Access Compliance Report

(Curb Ramps)

Intersection ID: N/A	Main Street: CLAVEMORR GLENN CT	Cross Street: CALLEY_GLENN_LN	Location: SW
ADA ID: 5DC373AB8E3D	Ramp Type: PerpDiag	Initial Pass/Fail: Fail	Overall Compliance: No
Severity Score: 8.75			
Codes/Mitigation Info/Possible Solution		Field Measurements/Component Compliance

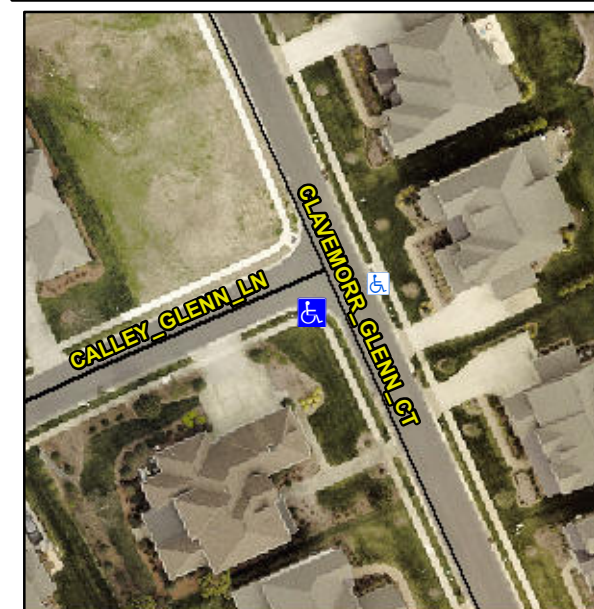
Not Found, R304.5.1

Remove & Replace Curb Ramp With Two New Directional Ramps or Equivalent.
